**UNITED NUCLEAR  
CORPORATION  
CHEMICALS DIVISION**

SUBJECT: APPLICATION FOR SOURCE AND SPECIAL NUCLEAR MATERIAL LICENSES  
FOR UNITED NUCLEAR CORPORATION'S SCRAP PLANT FACILITIES AT  
WOOD RIVER JUNCTION, RHODE ISLAND

Reference is made to your letter of January 22, 1964, in which you identify area for clarification or where additional information is required. Reference is also made to our conversation of January 23, at the plant site in Rhode Island.

Fig. 4—Values of  $\bar{u}x/Q$  as a function of downwind distance,  $x$ , m, for various weather types; source at surface.  $h = 10, 30$ , and  $100$  m, respectively.

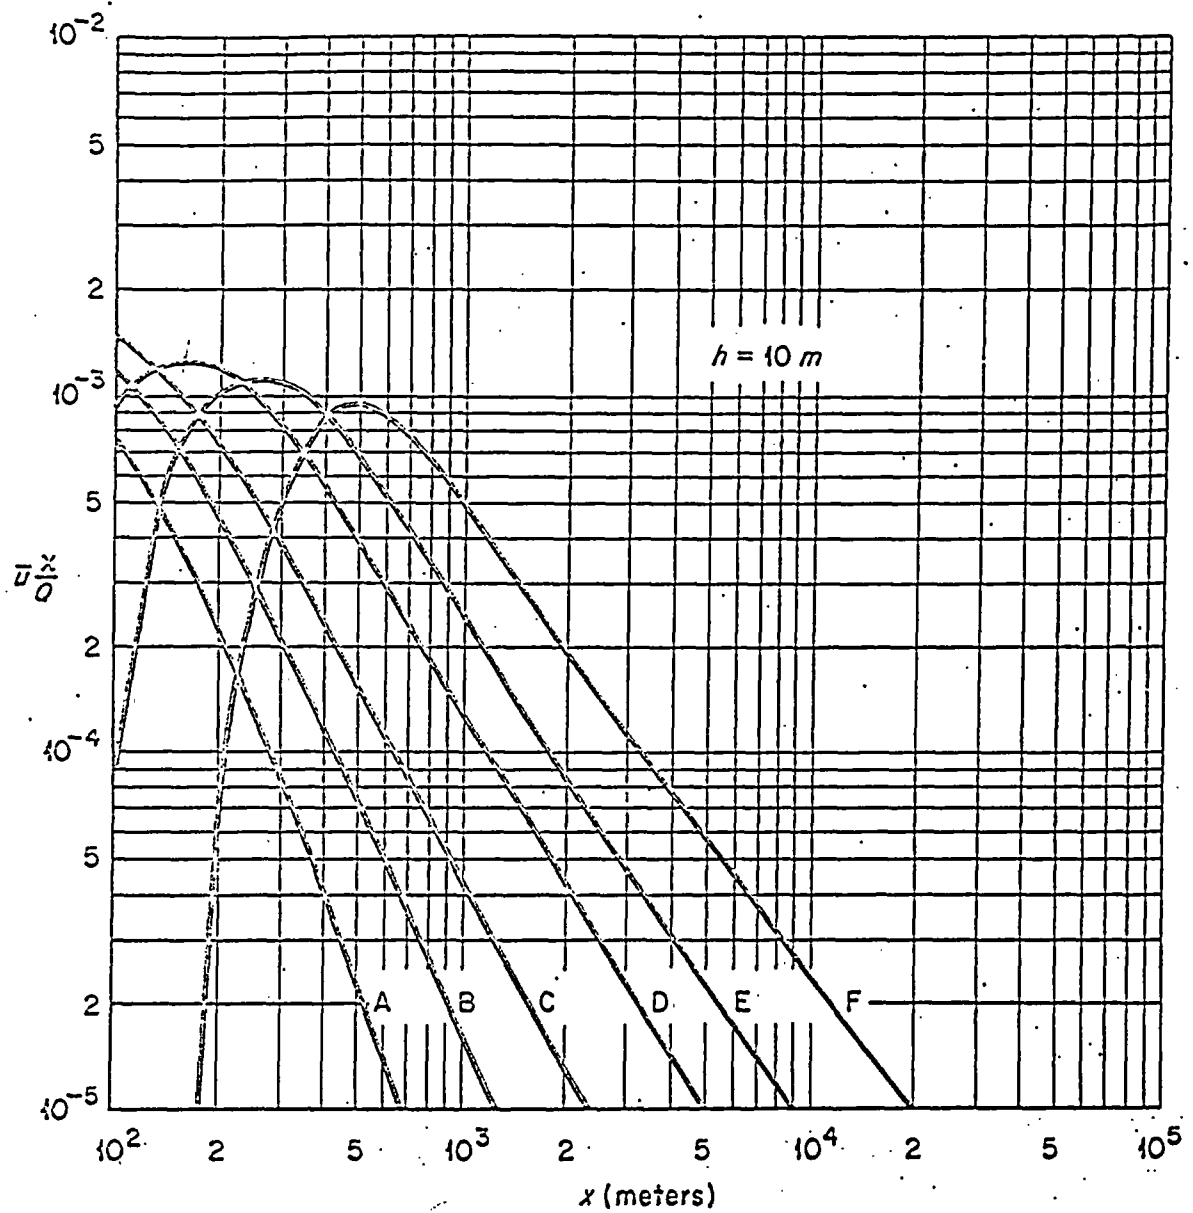
7. Air-borne Concentrations in Unrestricted Areas. Reference is made to ORO-545, using a stack height of 10 meters and average wind velocity of 6 miles per hour. We calculate that maximum concentration of materials discharged from process stacks occurs at a distance of 170 meters from the center of the plant. Concentrations will be determined at this distance downwind from the plant at least once per week. This concentration to be controlled to less than 10-CFR-20 limits.

For the physical layout of the Rhode Island plant, the values in the graph for h = 10 meter was used. These stack outlets

are approximately thirty feet above ground level. Prevailing weather conditions indicate that we use the value of curve D which gives

$$\bar{u} \left( \frac{X}{Q} \right)_{\max} = 1.3 \times 10^{-3}$$

which occurs at 170 yards.

Therefore the maximum air concentration from plant exhaust stack effluent would occur at approximately 170 yards from the center of the stacks.
